Delmore Fast Track Application

Appendix 8: A29 (Parks) to Response to Comments letter

Re: Parks Response Memorandum

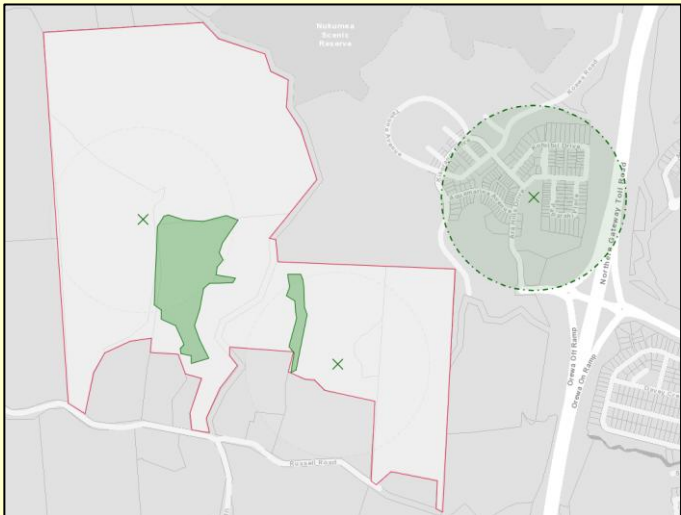
Information Request from Council on the lodged material	Applicant Response	Information Request / Technical Comment from Council under section 53 FTAA	Applicant Response under Section 55 FTAA
1. Open Space outcome for Lot 5020 is not protected	The applicant is willing to provide a neighbourhood park within Stage 1 where Council confirms its intention to acquire	Outstanding – The applicant has considered the residential society outcome for 5020 but not considered this for Lot 1800. Park provision is therefore not protected.	B&A: Acknowledged as a point of disagreement between the applicant and Council. The applicant has

The residential society mechanism applied to Lot 1800 has not been extended to Lot 5020. Unclear long-term ownership, management, and public access arrangements.	and vest the land, noting the proposed park meets the relevant size, accessibility, and design requirements. It is also our understanding that reserve acquisition is funded through development contributions, and therefore there is an appropriate mechanism available to enable Council to secure this land. However, if Council does not wish to acquire the land, it is appropriate that the area be developed for residential purposes. This is justified on the basis that the adjoining Ara Hills development is required to deliver a neighbourhood park which would adequately service future residents of the Delmore site. In contrast, the retention of	It is positive that the applicant intends to retain a degree of open space provision regardless of whether acquisition proceeds. The proposal to maintain the Stage 2 park in perpetuity through a residents' society acknowledges existing gaps within the open space network in this greenfield context. Figure 1 presents a gap analysis which indicates that the level of service for both Stage 1 and Stage 2 parks is largely contained within the scope of the fast-track development. The Stage 1 catchment, modelled under a medium to high-density scenario, does not extend sufficiently to service other parts of the Ara Hills development (Figure 2). On this basis, the rationale used to secure the Stage 2 park through a residents' society due to a perceived network gap could equally be applied to the Stage 1 park, supporting its retention in perpetuity. 	demonstrated that the Stage 1 park meets the required Council metrics, is free from any structures and easements, and is free from overland flow paths and flooding. Therefore, there should be no reason for Council not to acquire the park if Council considers it necessary for this stage of the development, as it is in accordance with Parks Policy. It is unclear why Council is requesting that this may need to sit within the responsibility of a Resident's Society. It is also our understanding that reserve acquisition is funded through development contributions, and therefore there is an appropriate mechanism available to enable Council to secure this land.

a neighbourhood park within Stage 2 is supported, as this location is more removed from adjoining neighbourhood parks and is necessary to ensure an appropriate distribution of parks across the wider catchment.	<i>Figure 1: Existing provision within wider catchment.</i>  <i>Figure 2: Updated catchment of Delmore park locations.</i>
